NOTICE OF OPPORTUNITY FOR PUBLIC COMMENT

ON THE PROPOSED DENIAL OF UNDERGROUND STORAGE TANK CASE CLOSURE FOR RCH CORPORATION 7891 STOCKTON BOULEVARD SACRAMENTO, CALIFORNIA

ORDER WQ 2010-XXXX-UST

In the Matter of the Petition of
RCH CORPORATION for Review of Denial of Petroleum Underground Storage Tank
Case Closure
at 7891 Stockton Boulevard, Sacramento, California

FIGURE 1: TPHg CONCENTRATIONS IN PERIMETER WELLS

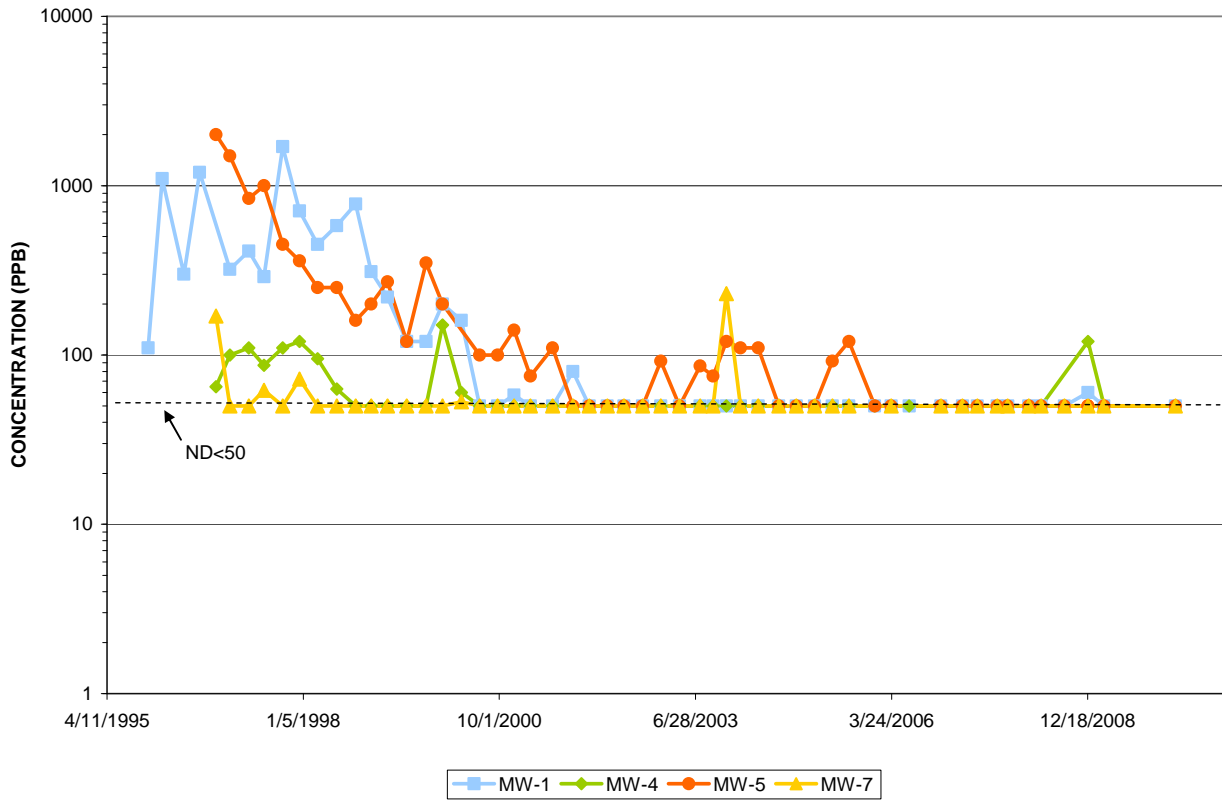
As the graph below depicts, there is a decreasing trend of TPHg concentrations in perimeter wells MW-1, MW-4, MW-5, and MW-7. This decreasing trend demonstrates that the remaining petroleum hydrocarbon mass is likely confined to soils in the central portion of the Site near the gasoline and diesel UST area and that the groundwater plume that is monitored by the existing well network is likely shrinking by natural attenuation (Figure 1).
